AGENDA
TOWN OF LISBON & VILLAGE OF MERTON
JOINT PLANNING COMMITTEE MEETING
VILLAGE OF MERTON COMMUNITY CENTER
TUESDAY, AUGUST 20, 2019
6:30P.M.

PROJECT:
THE PRESERVE AT HARVEST RIDGE
SINGLE FAMILY CONSERVATION SUBDIVISION
TOWN OF LISBON, WISCONSIN
BY: NEUMANN DEVELOPMENTS, INC.
N27W24025 PAUL COURT, SUITE 100
PEWAUKEE, WI 53072

To: Chairperson Osterman
Town Plan Commission Members
Gina Gresch, Town Administrator

From: Daniel J. Lindstrom, AICP, Town Planner
Aaron Prichard, Community Development Consultant

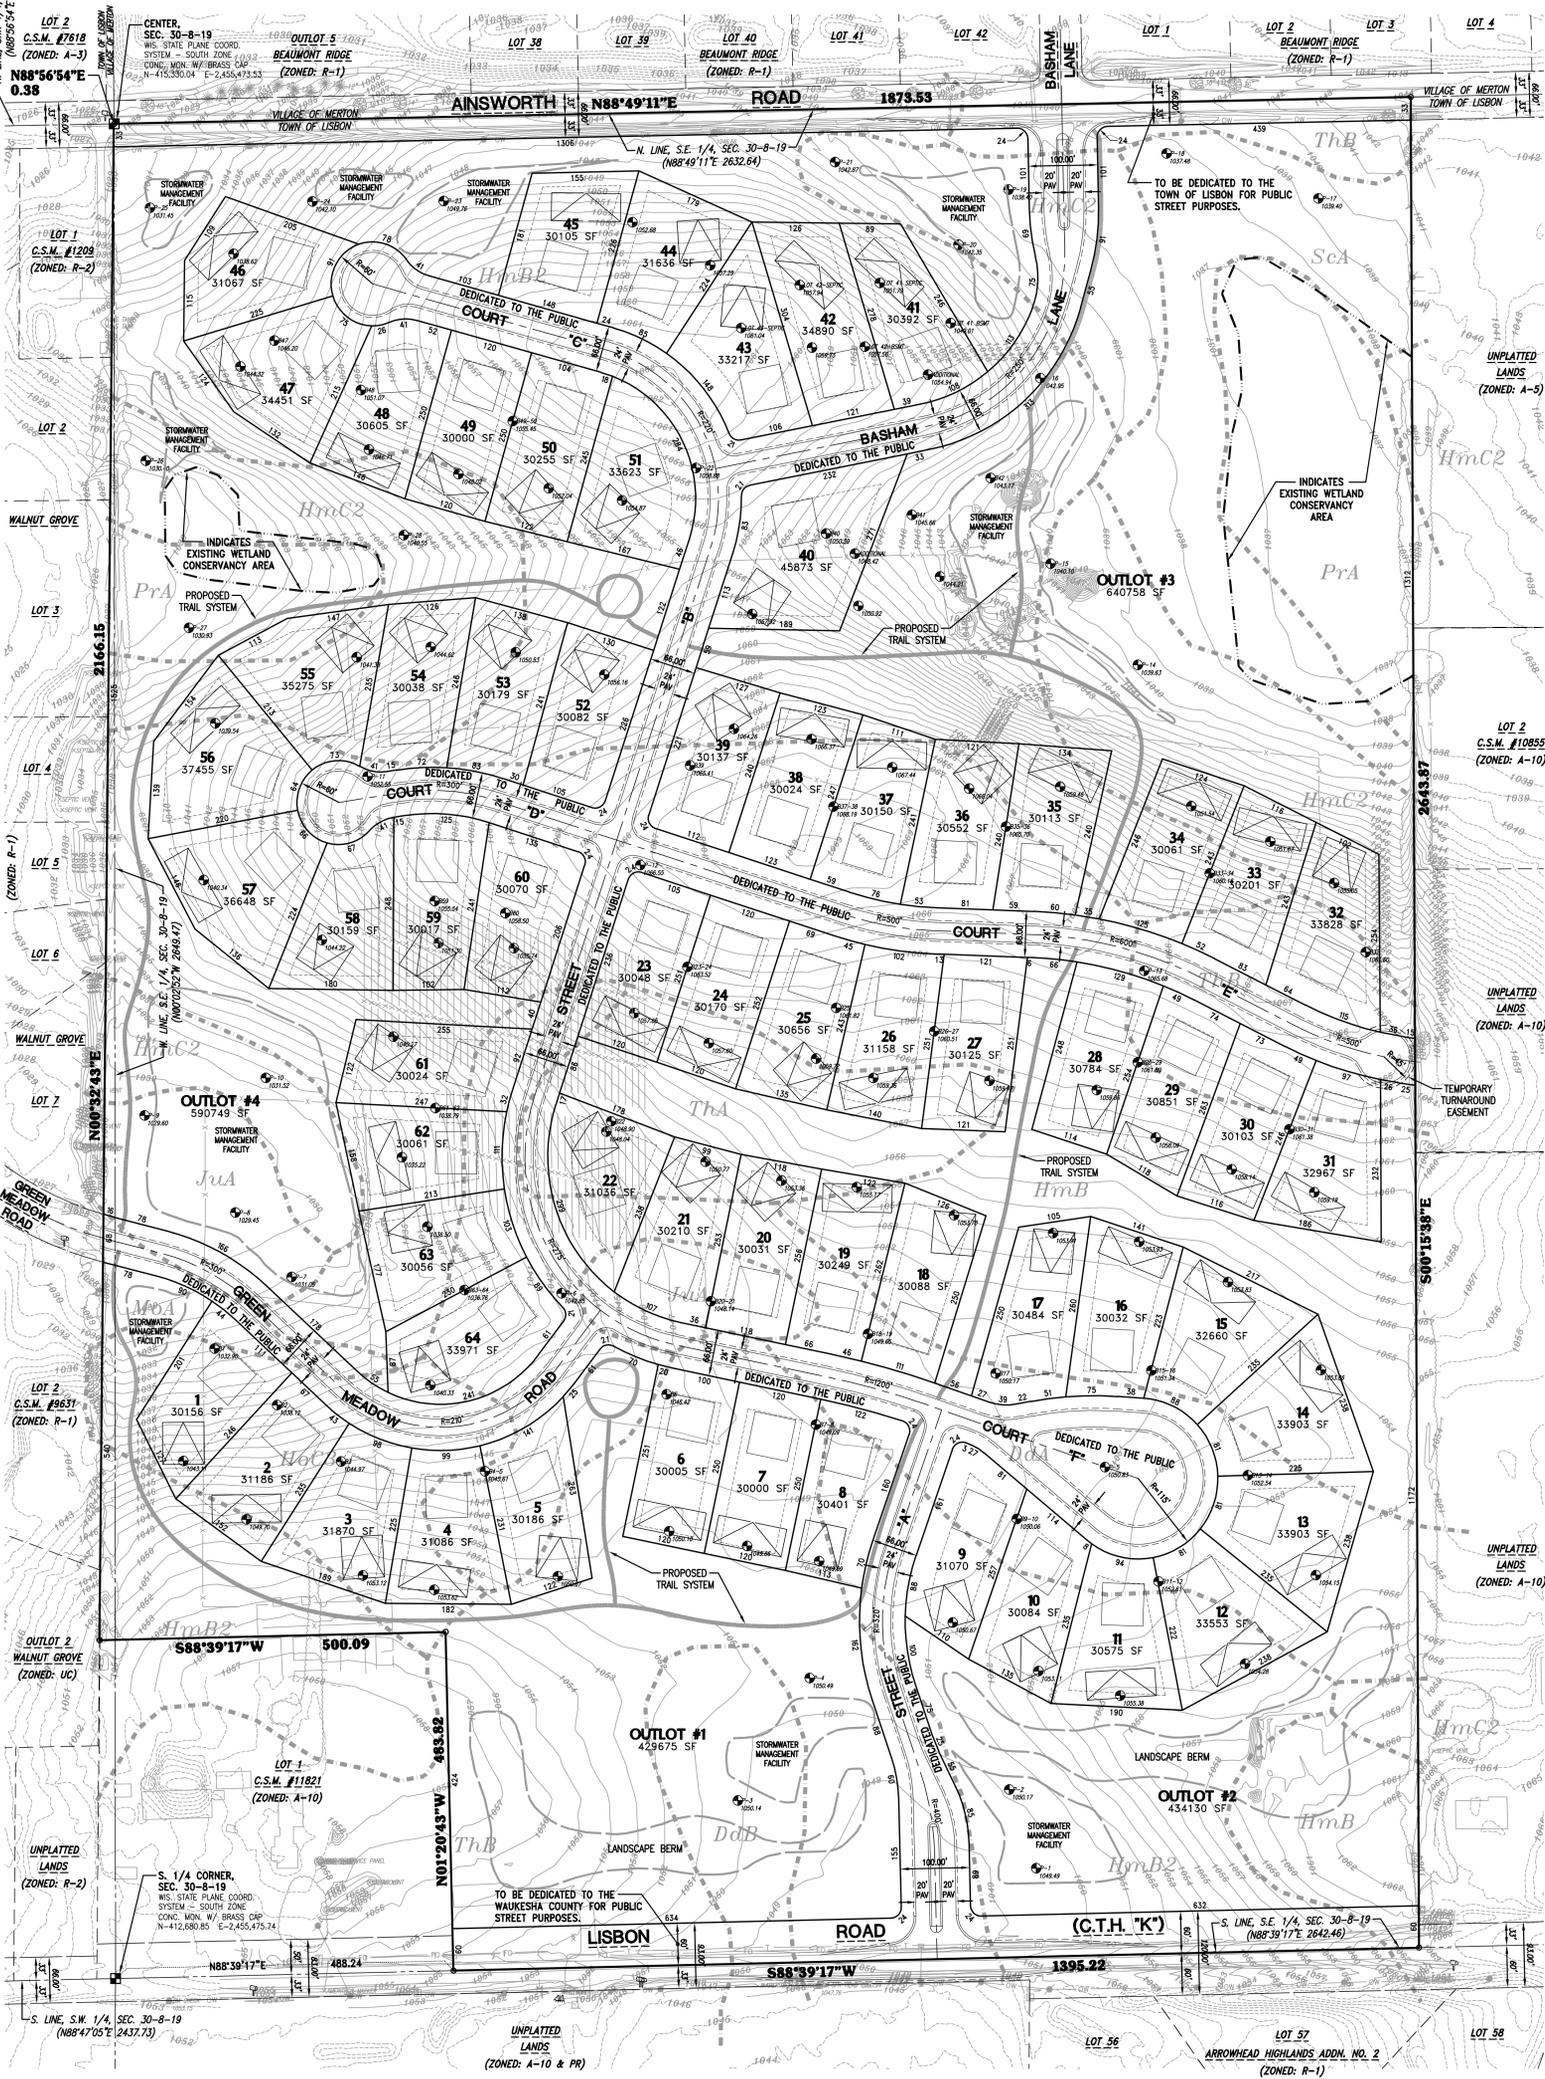
On the final plat, show the SW1/4 of Section 30 as well as the SE1/4, and label them accordingly.

In the next submittal, the applicant should include a cover letter responding to all of the following comments. The plat should be split into multiple pages for readability. Additionally, several pages of the civil drawings appear to be having an error in the PDF rendering. These should be revised and resubmitted to the Town for review.

- The portion between the two curves on Green Meadow Drive that is within the Preliminary Plat boundaries may be short of the required 100' for the length of a tangent between two curves. The Applicant shall amend the Preliminary Plat to show all tangent lengths and make necessary changes to the rights-of-way if any are short of requirements. If a tangent length must be less than 100' between curves please state the reason why and request it as a waiver from the Town Board.

- All streets or systems of streets designed to have one end closed, whether temporarily or permanently, shall not exceed in any manner 500 feet in length. Due to previous discussions with the Plan Commission, the Applicant shall request a formal waiver from this requirement for Court "E" due to the expanded cul-de-sac bulbs and discussions with the Fire Department.

- Include a summary table detailing the findings of the soil analysis and state which lot are to be served by a mound or conventional systems. Note 4 could be revised to include a statement if the subdivision is to be served entirely by one type of private on-site wastewater treatment system

- Include the following note on the Final Plat: "All side and rear lot lines not regulated by Waukesha County or the Town of Lisbon shall be graded and maintained in cooperation with abutting property owners so as to neither impede the flow of stormwater, nor negatively impact any abutting property, while also adhering to the established, approved, and accepted stormwater management plan."
- Include drainage swales necessary to direct water from the rear of lots and outlots to designated basins. Any planned stormwater easements shall be labeled.

- Provide the DNR wetland confirmation for the wetlands and state the date of wetland inventory.
- Revise the Wetland Preservation Restrictions to reflect the example attached to this review letter.

- Revise the development summary to also include the following information
 - Area of the development in acres.
 - Overall development density factor.
 - Approximate length of new roadways.
